ADDENDUM NO. 1

Project Name: Hobart Park Baseball Field Project

Bid Number: 2020005

This addendum is being released to answer questions received to date, to modify the bid documents, and to provide the pre-bid meeting minutes.

NO.	DATE	DESCRIPTION	DR/APP
1.	9/11/19	REVISED CHAIN LINK FENCING	SH/SEM
2.	6/11/18	REVISED PER IRC TRC COMMENT LETTER OF 6/14/18	SH/SEM
1.	5/10/18	REVISED PER IRC PRE-APP COMMENTS	SH/SEM

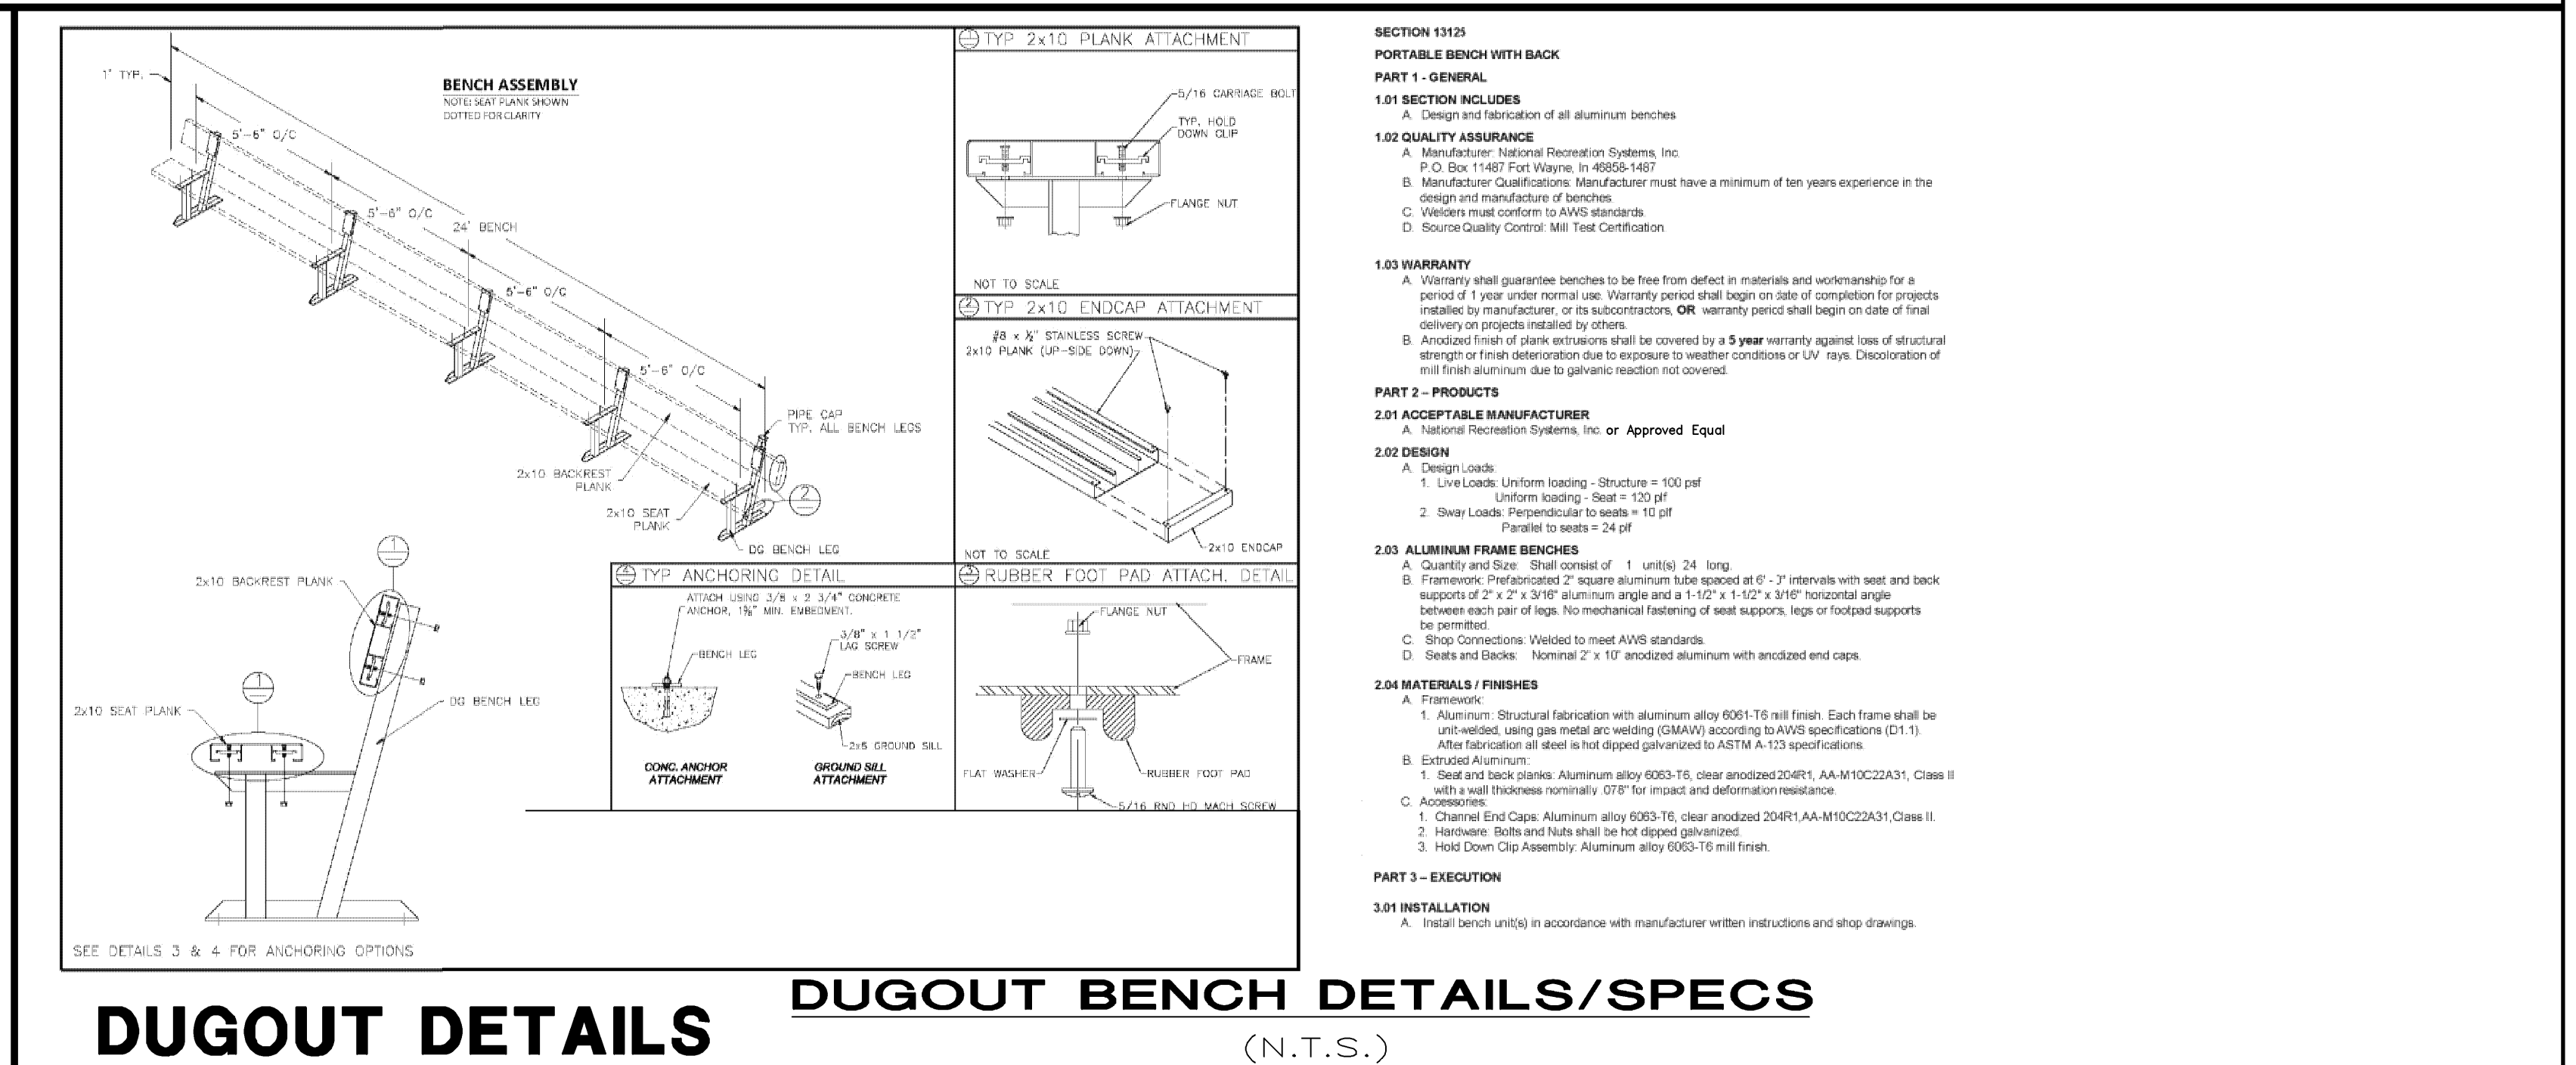
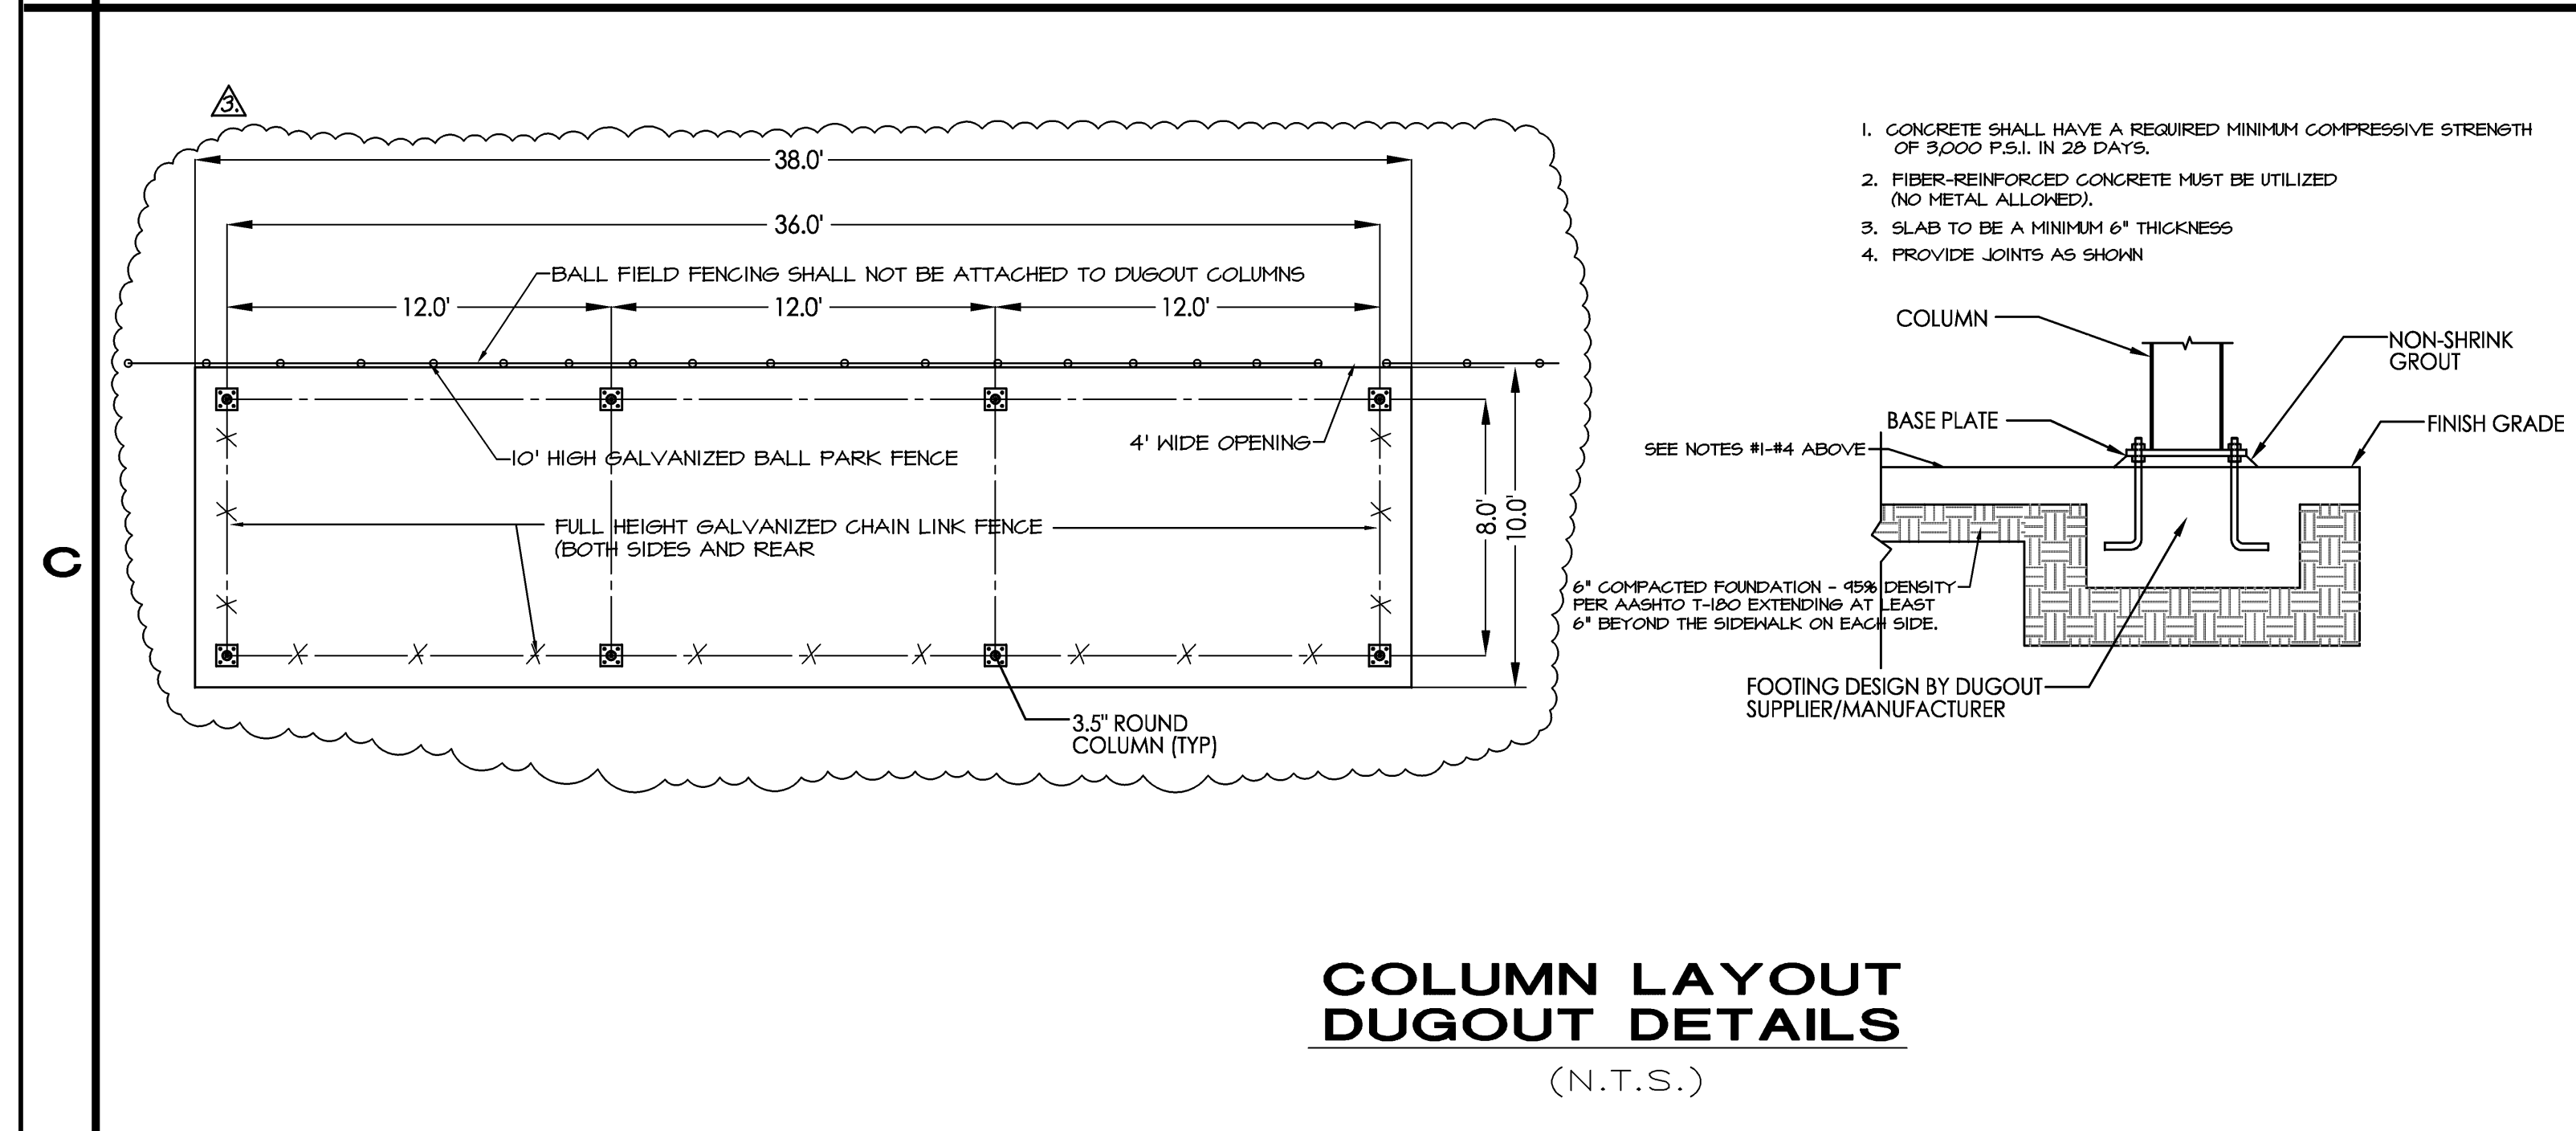
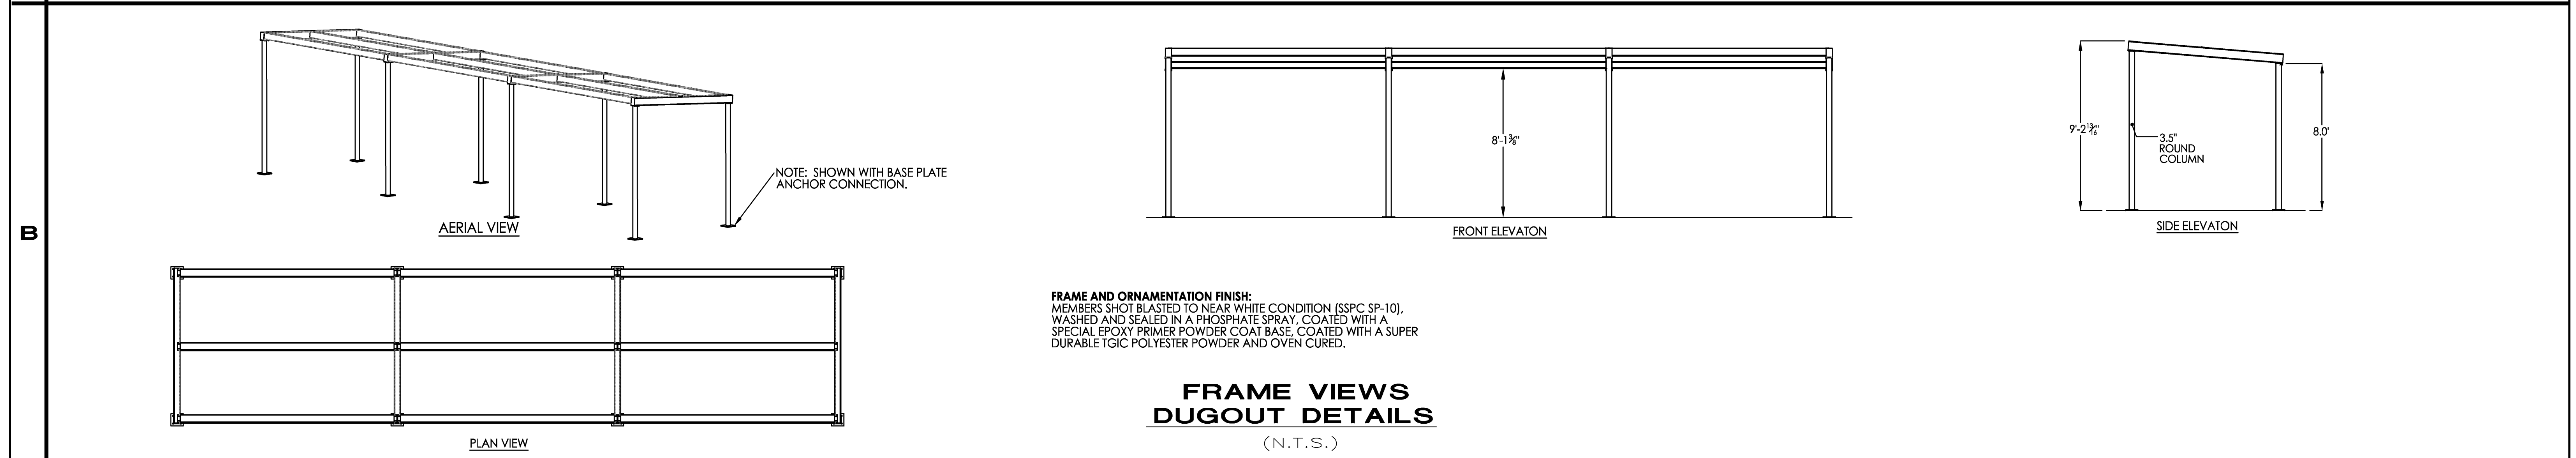
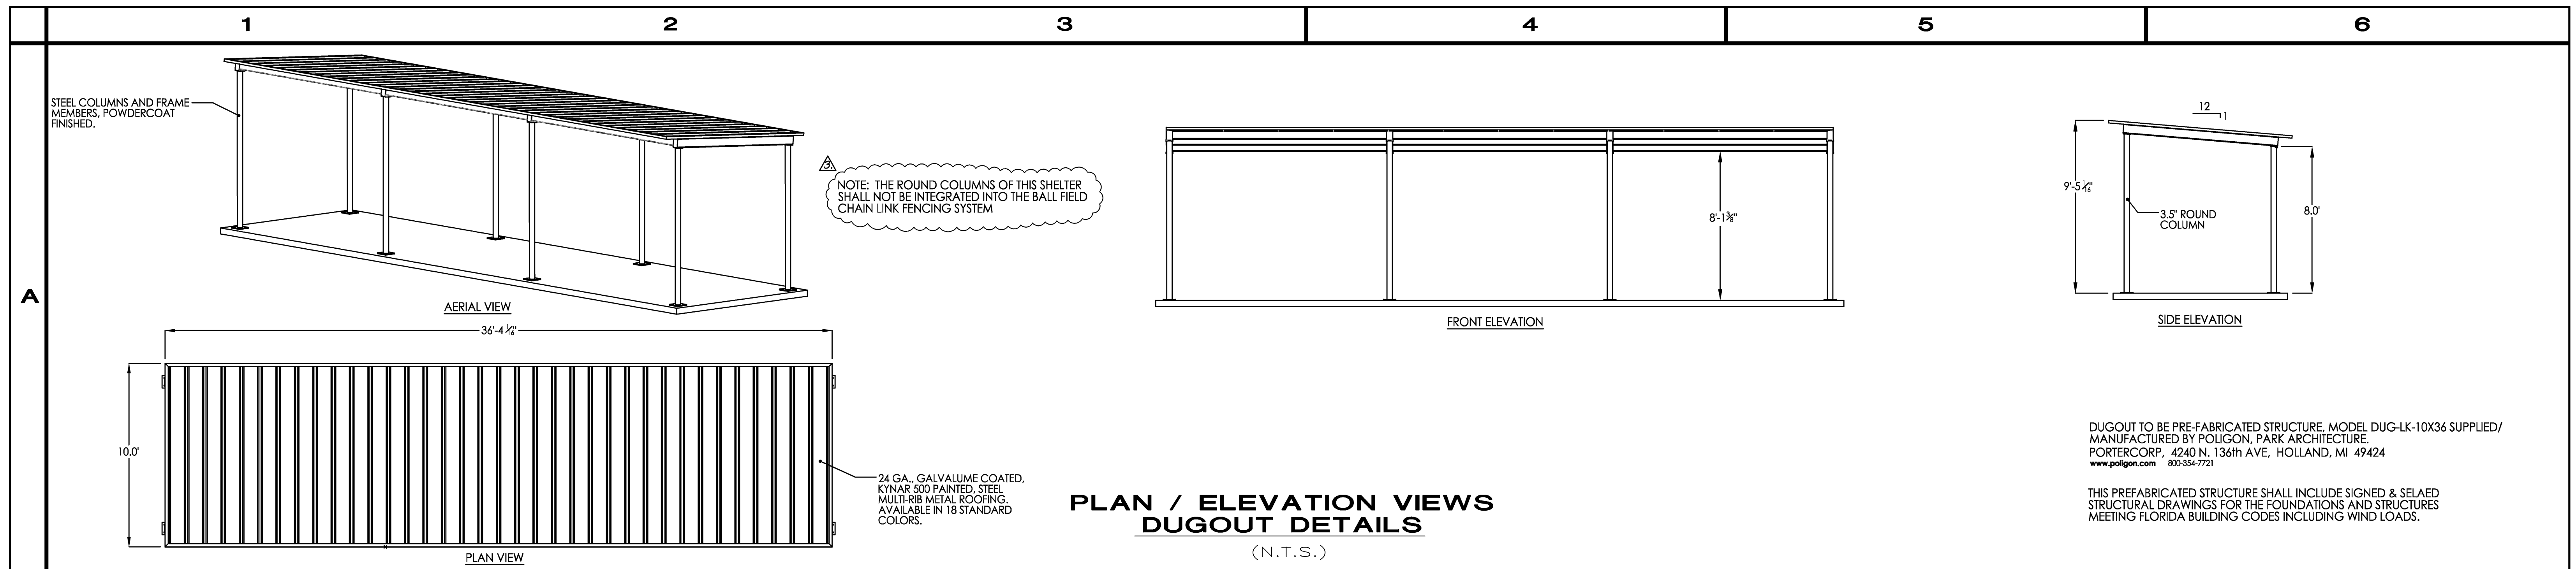
1. The fence from the backstop to the end of the bull pen areas have been increased in height from 6' to 10';
2. The fencing surrounding the bullpen areas has been raised from 6' to 10';
3. The Dugout details have been revised to clearly depict 10' high field protective fencing as not being supported by the dugout structure columns.
